Executive Director's Recommendation

Commission Meeting: March 7, 2019

PROJECT National Zoological Park Supplemental Perimeter Fencing 3001 Connecticut Avenue, NW Washington, DC	NCPC FILE NUMBER 7986
SUBMITTED BY Smithsonian Institution	NCPC MAP FILE NUMBER 2.00(38.40)44886
REVIEW AUTHORITY Federal Projects in the District per 40 U.S.C. § 8722(b)(1) and (d)	APPLICANT'S REQUEST Approval of preliminary and final site development plans
	PROPOSED ACTION Approve preliminary and final site development plans with comments
	ACTION ITEM TYPE Staff Presentation

Figure 13

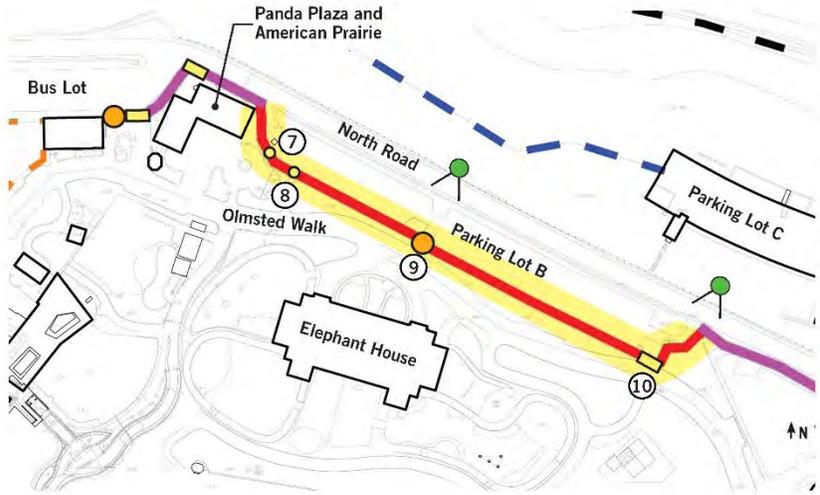
Staff also notes that a short segment of temporary chain-link fencing was proposed along the inside of Parking Lot B in the previous submission, with the expectation that Parking Lot B would become exhibit space when the proposed Central Parking Facility was built. The SI has indicated that it is not proceeding with the public-private partnership to build and operate the Central Parking Facility, and has ultimately decided to replace this segment with pedestrian ornamental fencing to reflect the continued need for parking at Parking Lot B. The portion of fencing that was proposed along the outside of Parking Lot B to support its future use as exhibit space has also been eliminated in this revised submission. The SI has indicated its intent to conduct a comprehensive update to the NZP master plan in the future, which would include a transportation component that considers long-term parking needs and would revisit the idea of a structured parking facility. The master planning process would include opportunities for public input and comment.

Figure 14

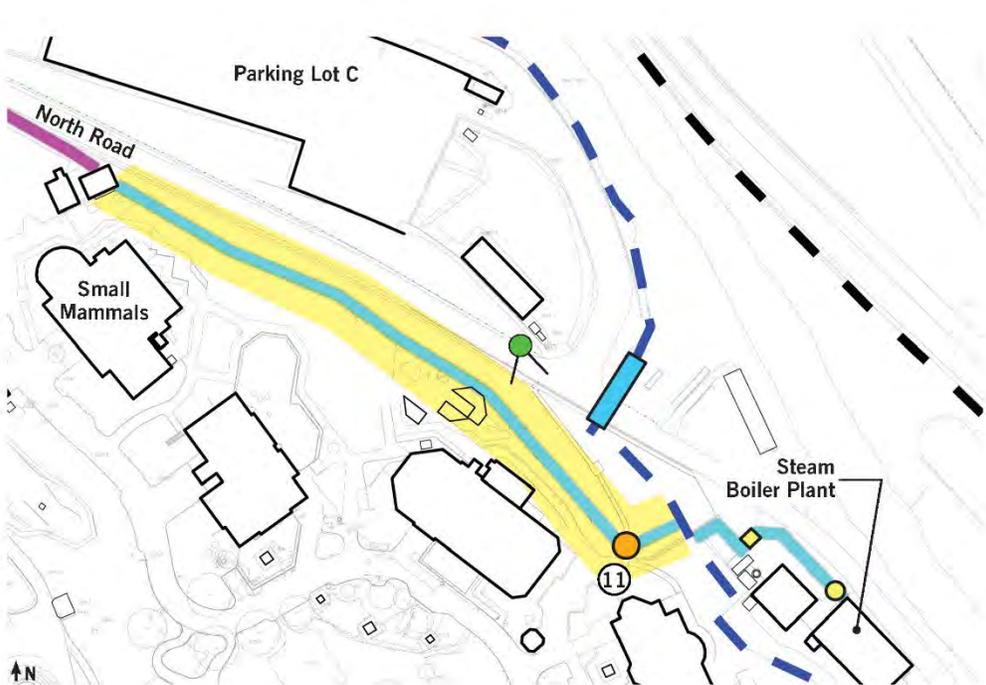
In its review of the concept plans for the supplemental perimeter fencing project, staff noted that a portion of chain-link fencing near the zoo entrance at Parking Lot C would be visible from public areas along North Road. The Commission requested that the applicant consider moving this portion of fencing further back into the vegetation to reduce visibility or use ornamental fencing. In the current submission, the applicant has chosen to use chain-link fencing in this location, but has realigned the segment further back into dense vegetation in this area. The new alignment also pulls this portion of fencing away from North Road and allows open pedestrian access to the sidewalk along North Road. Staff notes that the chain-link fencing has a lighter, more porous profile than the ornamental fencing, which is ultimately less visible in such vegetated areas, and feels that this solution adequately addresses Commission comments on the concept design.
